Work Order ID 76915

Item Name: Crosstube Turning Detail

DRAWING NO. D212-664-141	TITLE XTUBE ASSY (205/212/412 HI FWD)	REV. D	DART AEROSPACE LTD ENGINEERING ORDER		D.E.O. NO. D212-664-141-D-1	SHEET NO. SHEET 1 OF 2	SCALE NTS
DRAWN	CHECKED		MFG. APPR.		APPROVED	DE APPR.	
DATE 11.04.07	DATE 11.07.11		DATE 11.04.12		DATE 11/04/12	DATE 11.04.12

DRAWING NO. D212-664-141	TITLE CROSSTUBE ASS'Y (205 HI FWD)	REV. D	<b>DART AEROSPACE LTD ENGINEERING ORDER</b>		D.E.O. NO. D212-664-141-D-2	SHEET NO. SHEET 1 OF 1	SCALE NTS
DRAWN <i>IP</i>	CHECKED <i>ASS</i>	MFG. APPR. <i>AS</i>	APPROVED <i>MP</i>		DE APPR. <i>MP</i>		
DATE 11.07.15	DATE 11.07.20	DATE 11.07.21	DATE 11/07/21		DATE 11.07.21

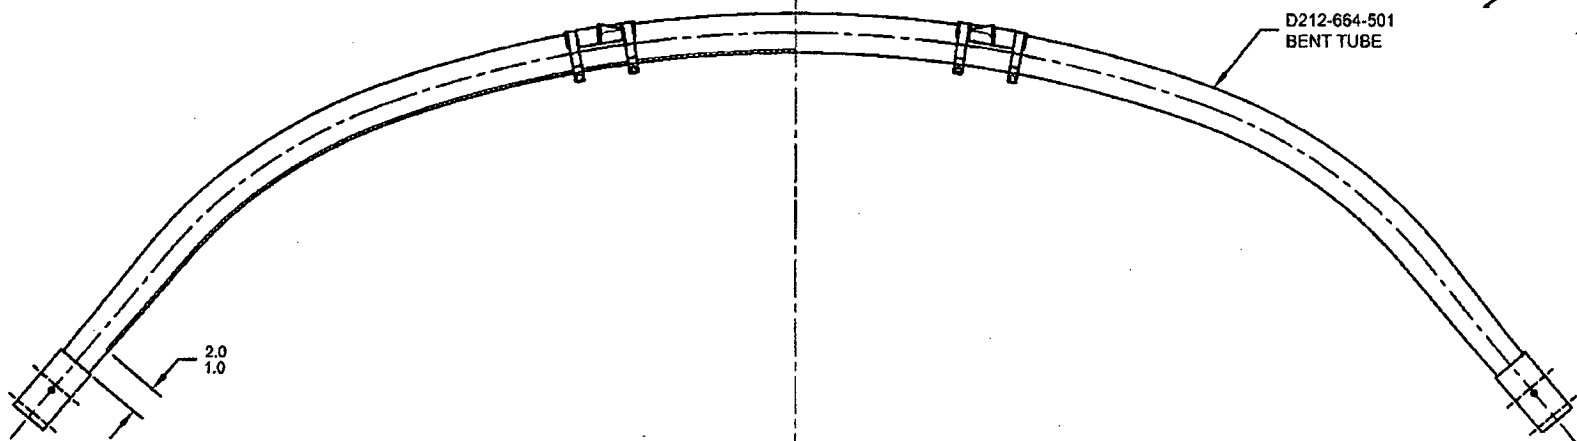
ADD AN INSPECTION WINDOW TO UNDERSIDE OF CROSSTUBE.

NOTES 2 OF SHEET 1 IS AMENDED AS FOLLOWS:

- 2) FINISH: CHEMICAL CONVERSION COAT PER DART QSI 005 4.1  
PRIME INSIDE AND OUTSIDE PER DART QSI 005 4.2  
MASK UNDERSIDE OF CROSSTUBE AS SHOWN (HATCHED AREA) AND  
PAINT OUTSIDE PER DART QSI 005 4.2  
REMOVE MASKING AND APPLY CLEAR COAT

- 2) FINISH: CHEMICAL CONVERSION COAT PER DART QSI 005 4.1  
PRIME INSIDE AND OUTSIDE PER DART QSI 005 4.2  
PAINT OUTSIDE PER DART QSI 005 4.2

**D212-664-141/-141B  
ASSEMBLY DETAIL**

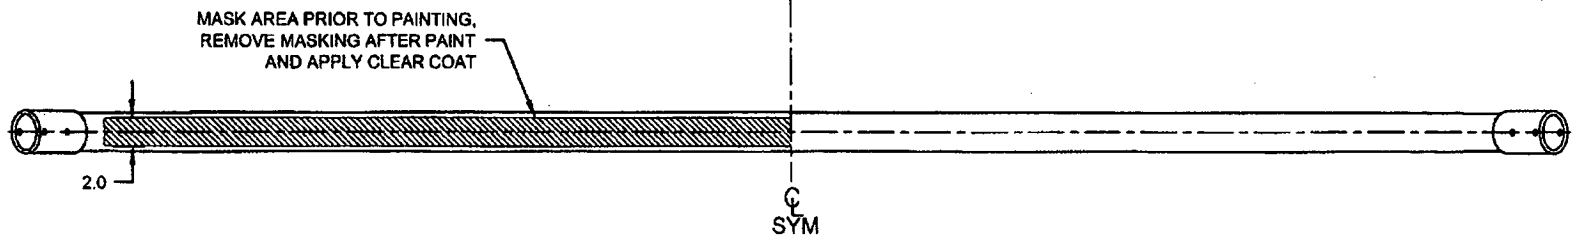
**IS:**

**WAS:**
